ADDENDUM NUMBER THREE
TO THE CONTRACT DOCUMENTS FOR CONSTRUCTION OF
ORANGE BEACH RECREATION COMPLEX
NEW BASEBALL/SOFTBALL FIELD RENOVATIONS AT ORANGE BEACH SPORTSPLEX
CITY OF ORANGE BEACH

This addendum forms a part of the Contract Documents and modifies the Bid Documents dated May 4, 2020.

This Addendum consists of three (3) page Addendum, one (1) general documents, one (1) Specification & thirteen (13) full-size sheets.

DRAWING NO. E500

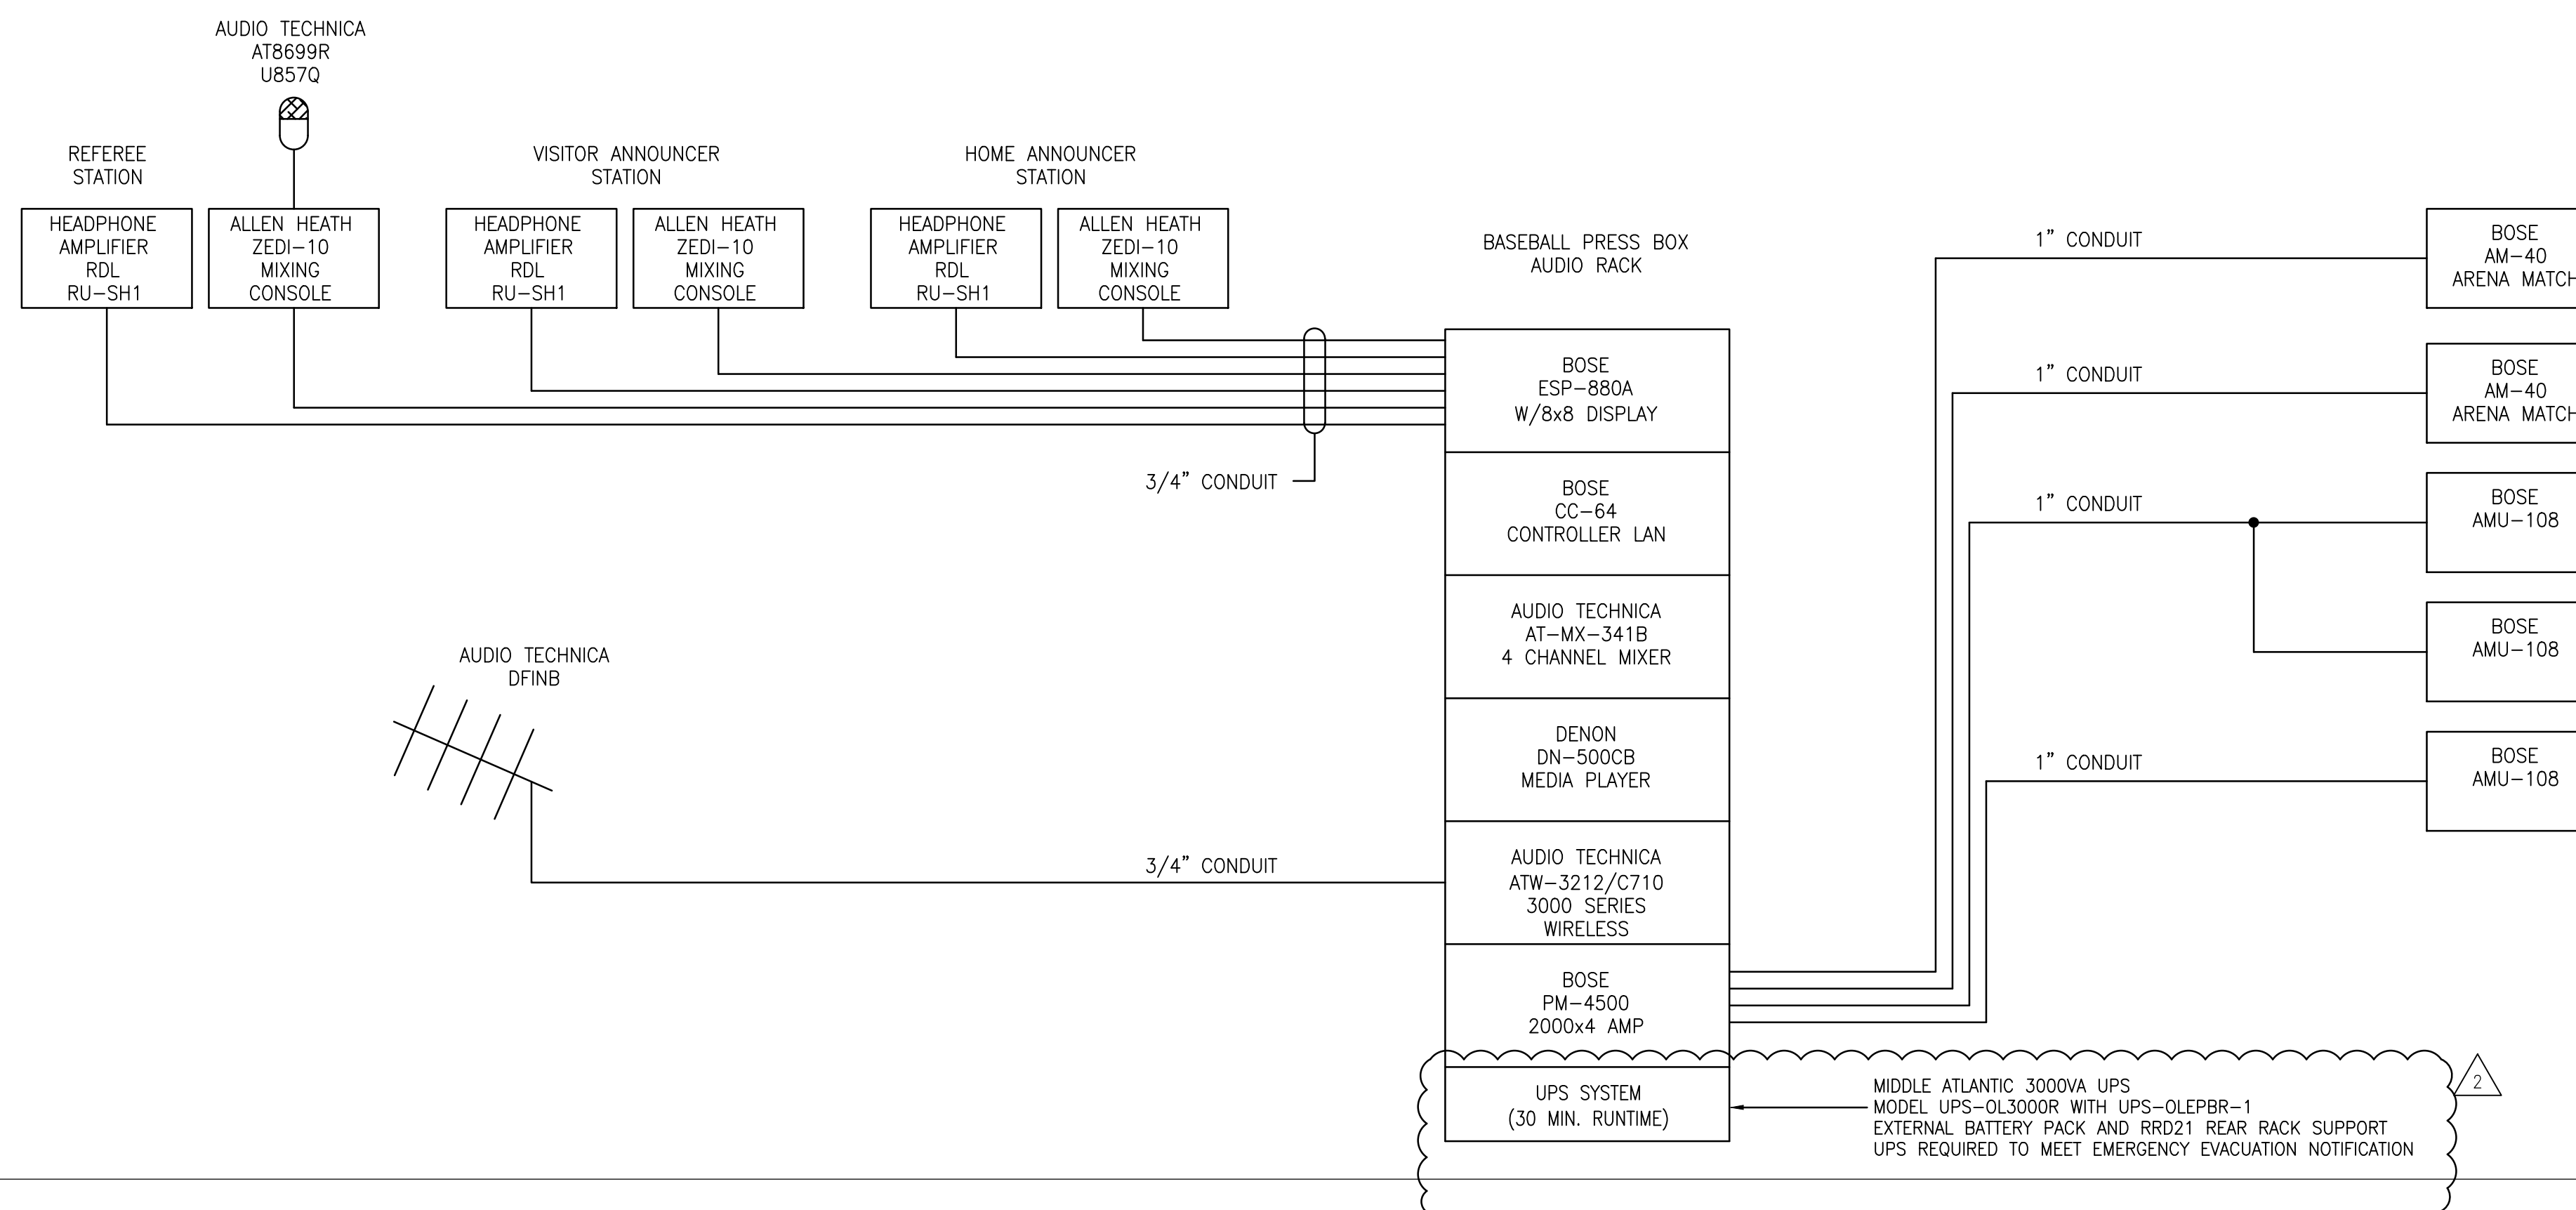
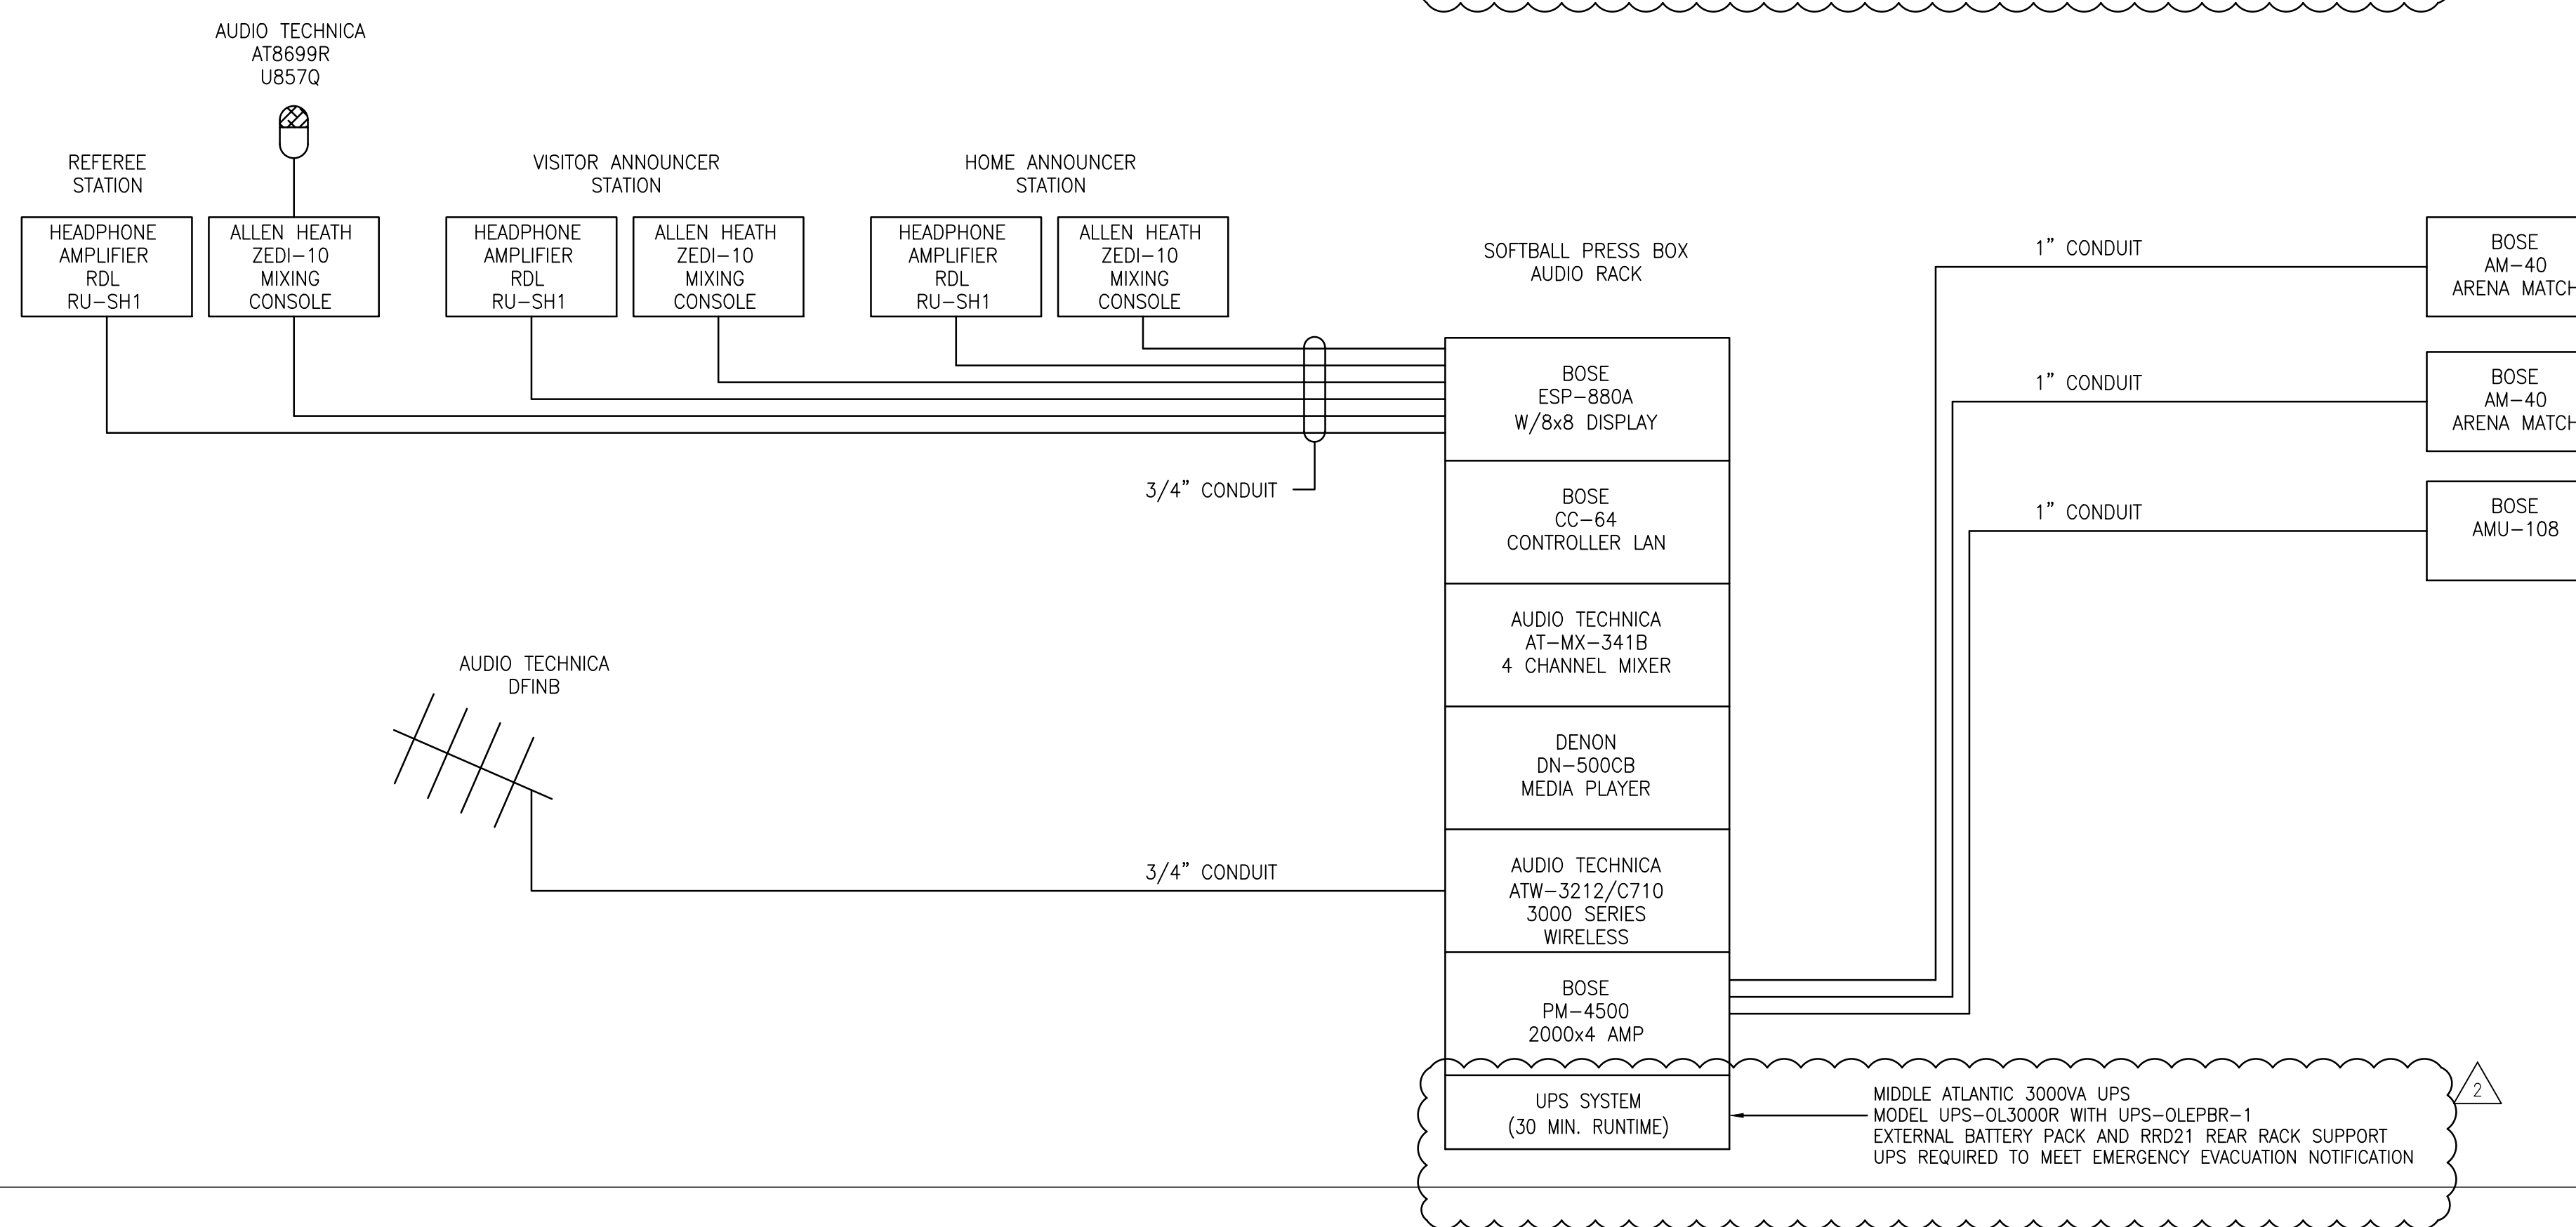
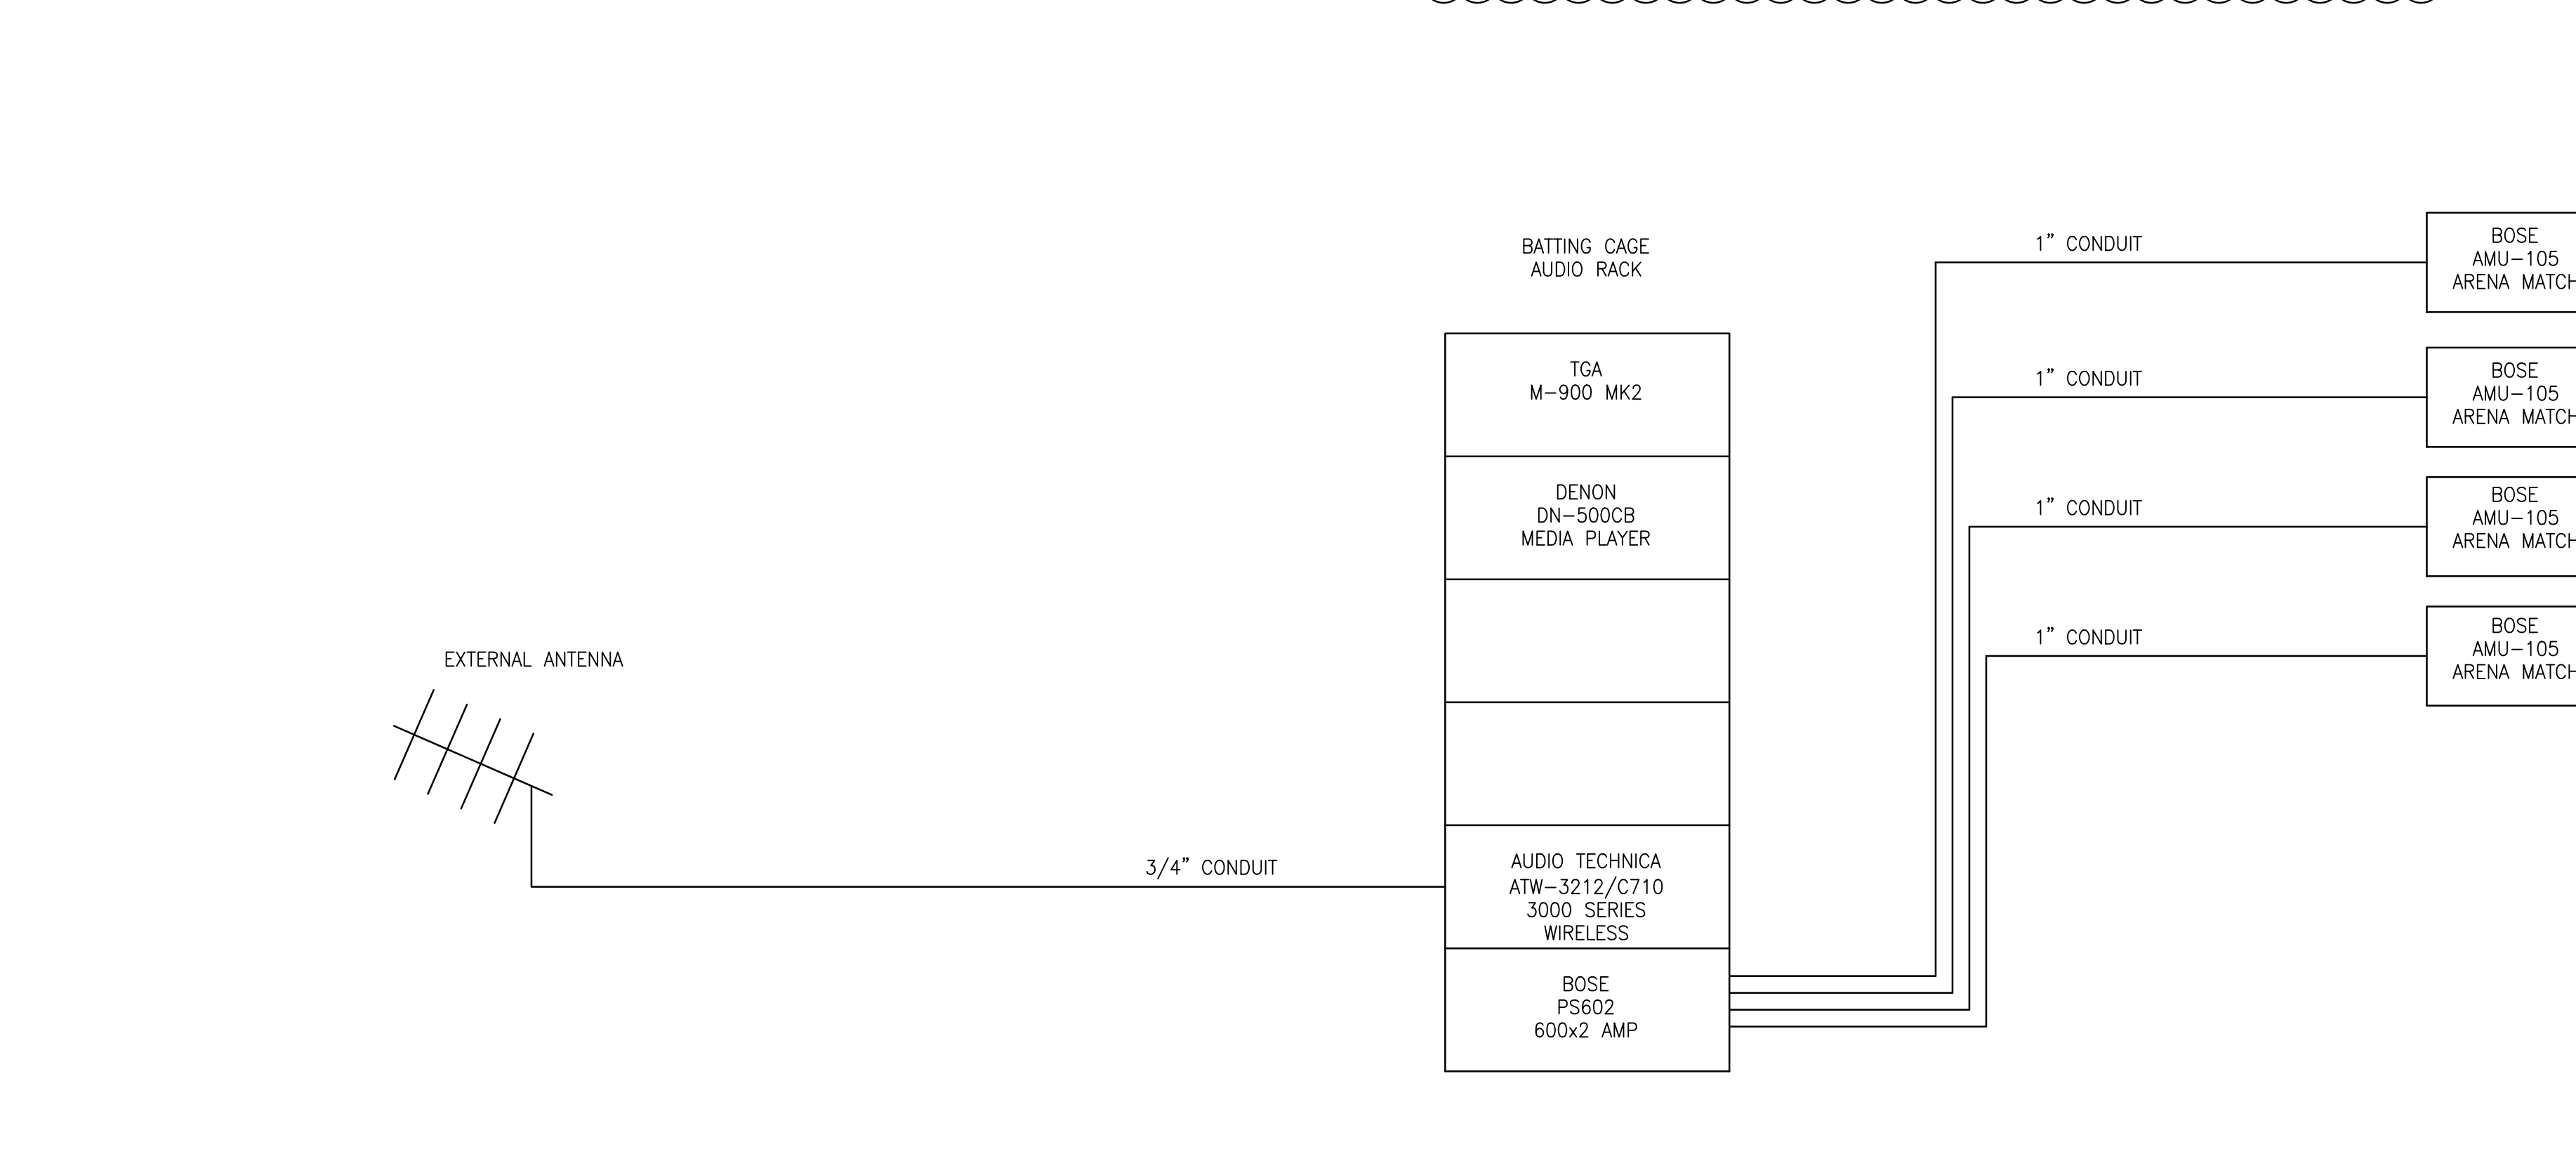
ITEM 12 SHEET E500 – AUDIO RISER DIAGRAM

1. Added additional information to the Audio System Notes.
2. Added 30 minute run time UPS to Baseball Field 2 Audio Riser Diagram.
3. Added 30 minute run time UPS to Softball Field 3 Audio Riser Diagram.
